EC–QC0CA–U1

DECchip 21140 PCI Fast Ethernet LAN Controller Hardware Reference Manual Update

This document provides updated information for the *DECchip 21140 PCI Fast Ethernet LAN Controller Hardware Reference Manual*, EC–QC0CA–TE.

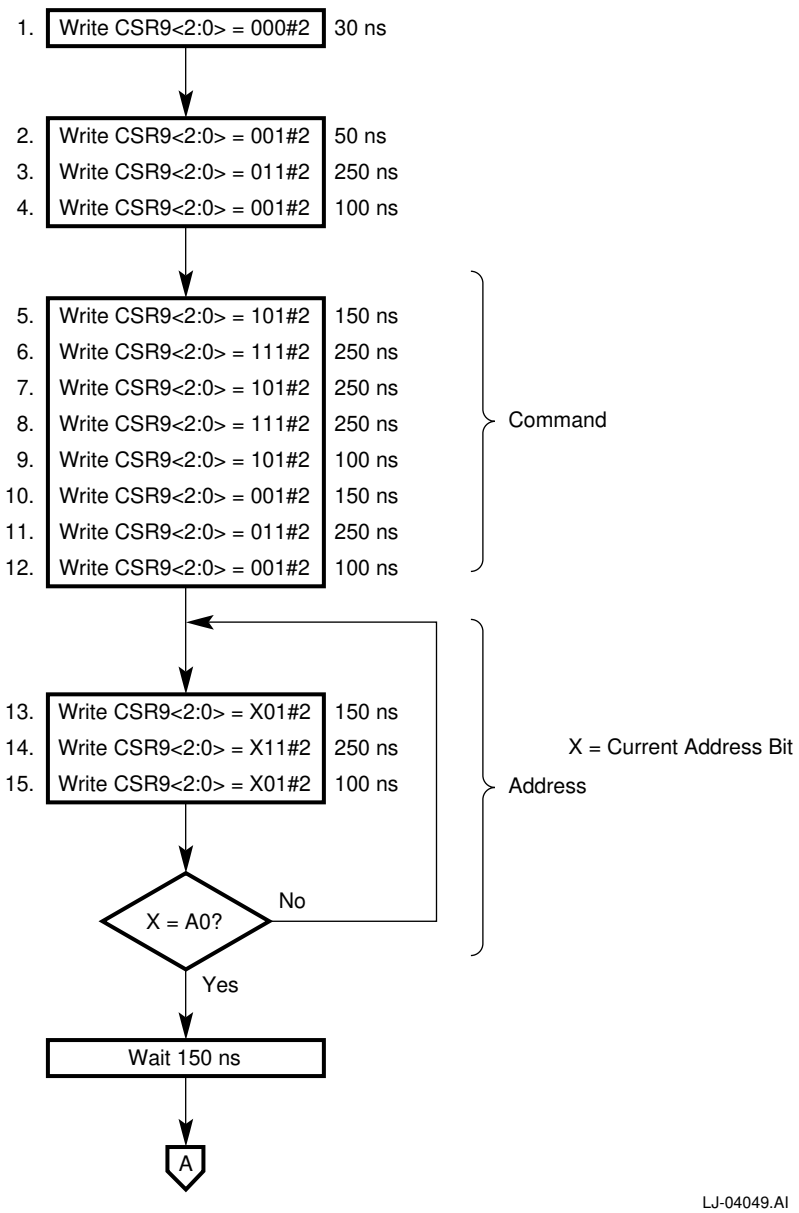
On page 7-3, in Section 7.2.1, **Read Operation**, replace the figure shown in Figure 7-2 Read Cycle (Page 1 of 2) with the following figure:

1. Write CSR9<2:0> = 000#2 30 ns
2. Write CSR9<2:0> = 001#2 50 ns
3. Write CSR9<2:0> = 011#2 250 ns
4. Write CSR9<2:0> = 001#2 100 ns
5. Write CSR9<2:0> = 101#2 150 ns
6. Write CSR9<2:0> = 111#2 250 ns
7. Write CSR9<2:0> = 101#2 250 ns
8. Write CSR9<2:0> = 111#2 250 ns
9. Write CSR9<2:0> = 101#2 100 ns
10. Write CSR9<2:0> = 001#2 150 ns
11. Write CSR9<2:0> = 011#2 250 ns
12. Write CSR9<2:0> = 001#2 100 ns
Command
13. Write CSR9<2:0> = X01#2 150 ns
14. Write CSR9<2:0> = X11#2 250 ns
15. Write CSR9<2:0> = X01#2 100 ns
X = Current Address Bit
Address
X = A0?
No
Yes
Wait 150 ns
A
LJ-04049.AI

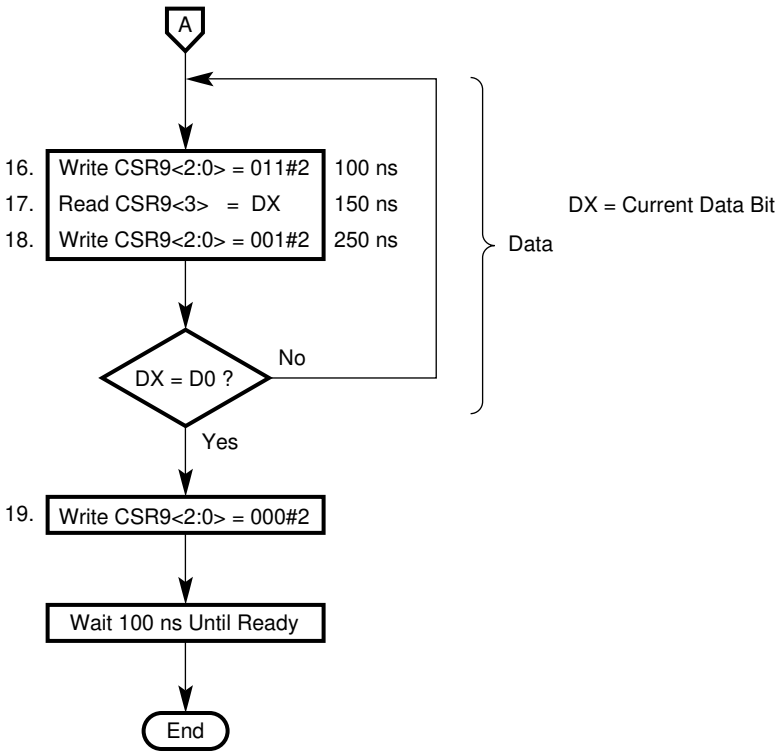
On page 7-4, in Section 7.2.1, **Read Operation**, replace the figure shown in Figure 7-3 Read Cycle (Page 2 of 2) with the following figure:

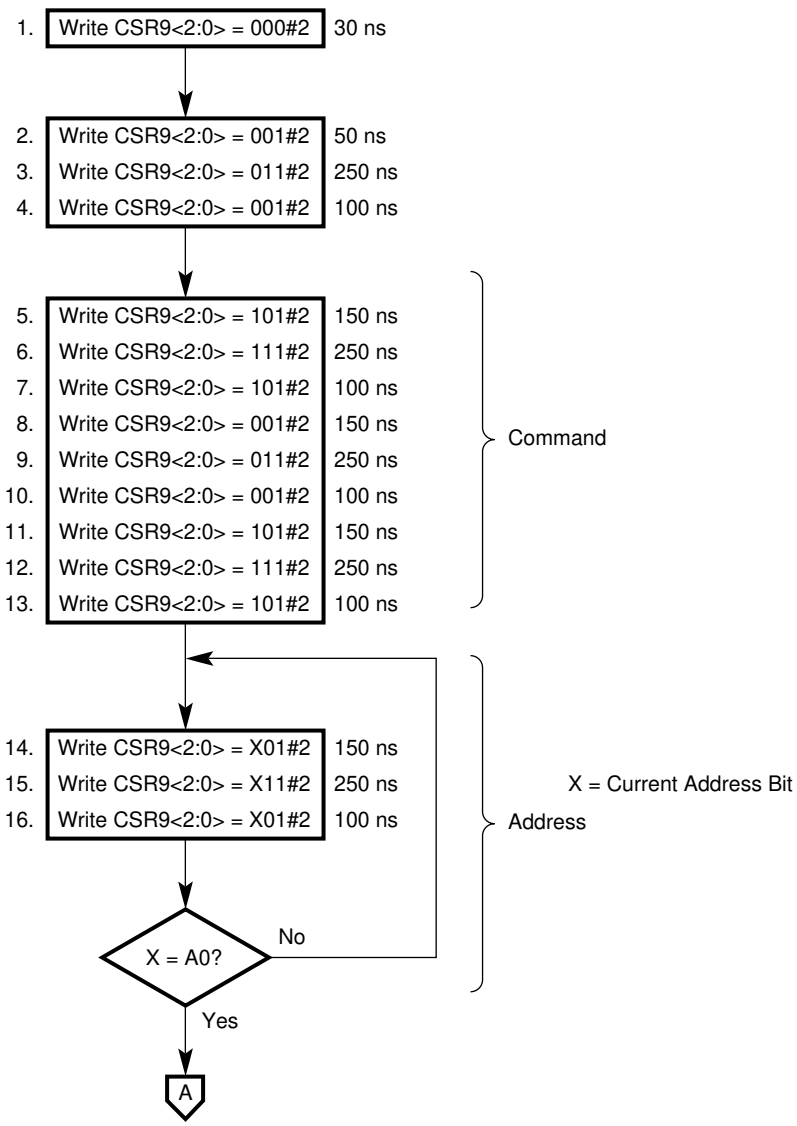
On page 7-6, in Section 7.2.2, **Write Operation**, replace the figure shown in Figure 7-5 Write Cycle (Page 1 of 2) with the following figure:

1. Write CSR9<2:0> = 000#2 30 ns
2. Write CSR9<2:0> = 001#2 50 ns
3. Write CSR9<2:0> = 011#2 250 ns
4. Write CSR9<2:0> = 001#2 100 ns
5. Write CSR9<2:0> = 101#2 150 ns
6. Write CSR9<2:0> = 111#2 250 ns
7. Write CSR9<2:0> = 101#2 100 ns
8. Write CSR9<2:0> = 001#2 150 ns
9. Write CSR9<2:0> = 011#2 250 ns
10. Write CSR9<2:0> = 001#2 100 ns
11. Write CSR9<2:0> = 101#2 150 ns
12. Write CSR9<2:0> = 111#2 250 ns
13. Write CSR9<2:0> = 101#2 100 ns
Command
14. Write CSR9<2:0> = X01#2 150 ns
15. Write CSR9<2:0> = X11#2 250 ns
16. Write CSR9<2:0> = X01#2 100 ns
X = Current Address Bit
Address
X = A0?
No
Yes
A
LJ-04052.AI

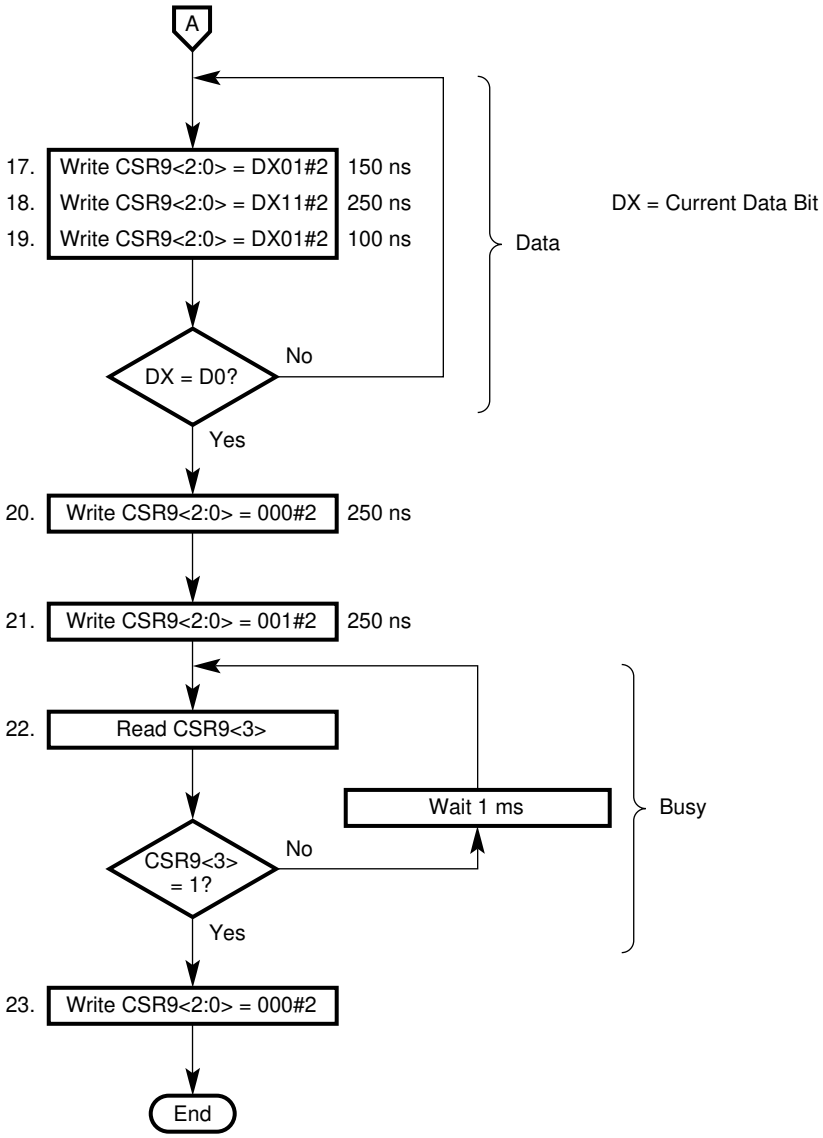
On page 7-7, in Section 7.2.2, **Write Operation**, replace the figure shown in Figure 7-6 Write Cycle (Page 2 of 2) with the following figure:
